Site Name: <u>Progress Energy Asheville</u>	Date: <u>29 MAY 2009</u>
Unit Name: <u>1964 POND</u>	Operator's Name: <u>PROGRESS ENERGY</u>
Unit I.D.:	Hazard Potential Classification: <u>High</u> Significant Low
Inspector's Name: <u>FREDERIC SHMURAK / JUSTIN STORY</u>

**ASHEVILLE STEAM ELECTRIC PLANT
COOLING LAKE DAM AND ASH POND DAMS
SKYLAND, NORTH CAROLINA**

**ASHEVILLE STEAM ELECTRIC PLANT
2007 INDEPENDENT CONSULTANT INSPECTION
COOLING LAKE DAM AND ASH POND DAMS
TABLE OF CONTENTS**

Photograph 8: Cooling Lake Dam – spalling concrete on ogee spillway.

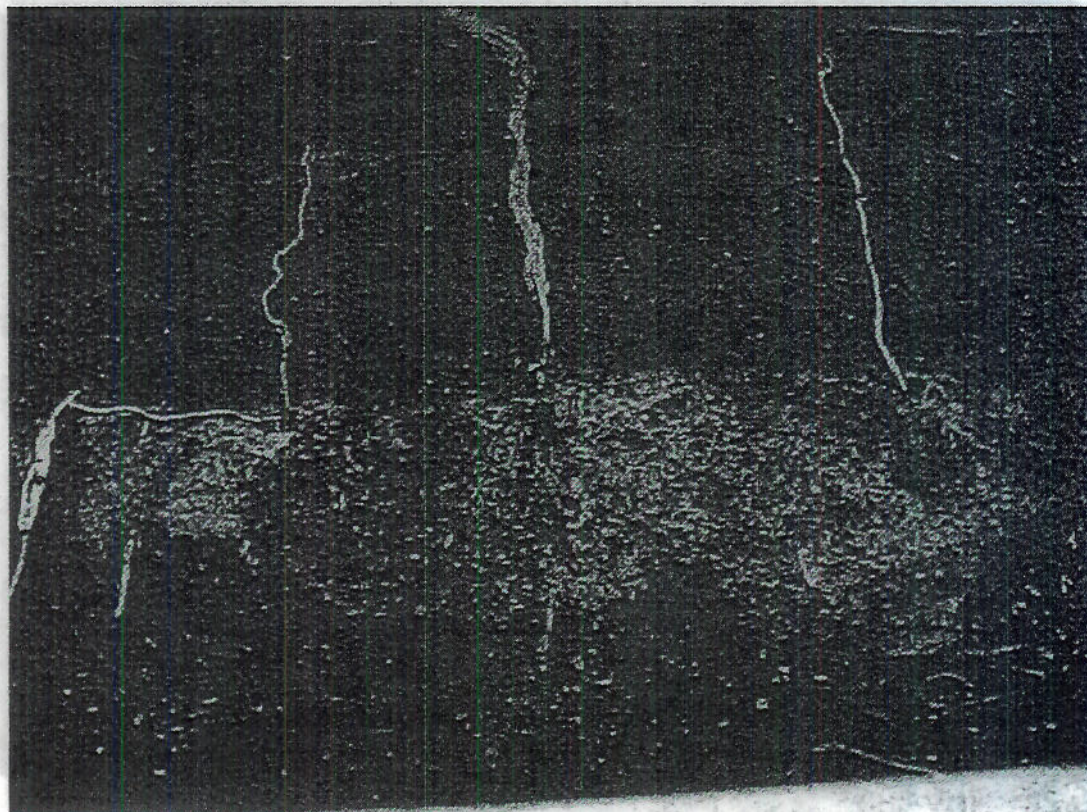
3. Repair the three areas of spalled concrete on the surface of the spillway slab.
4. Continue to remove accumulated sediment from behind the weir, as required.

Photograph 14: 1964 Ash Pond – seepage at toe of embankment, north of stilling basin.

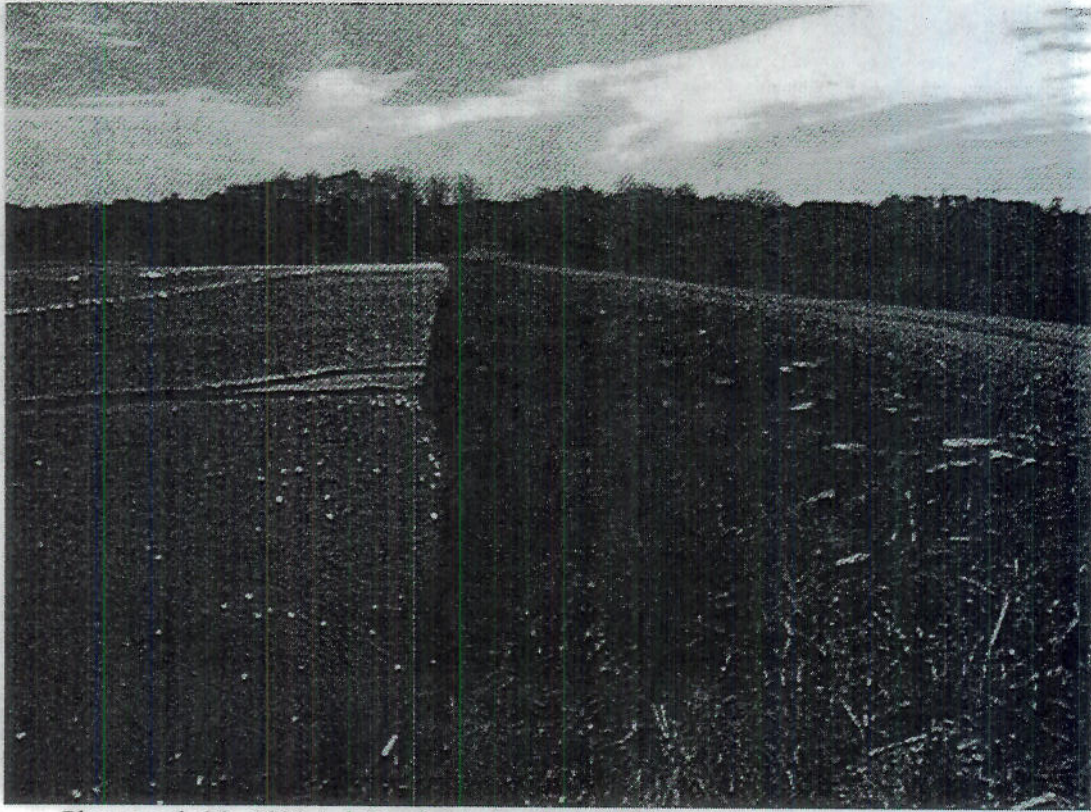
The natural seepage observed on the east abutment, near the downstream toe, was similar to that observed during previous inspections and is not considered a factor in dam safety or performance. Flow from the collector pipes installed in the sand blanket drain that passes through the seepage monitoring weir is clear (photograph 21). The weir and outflow channel are in good condition. Seepage flow monitoring records show no significant changes in flow rates.
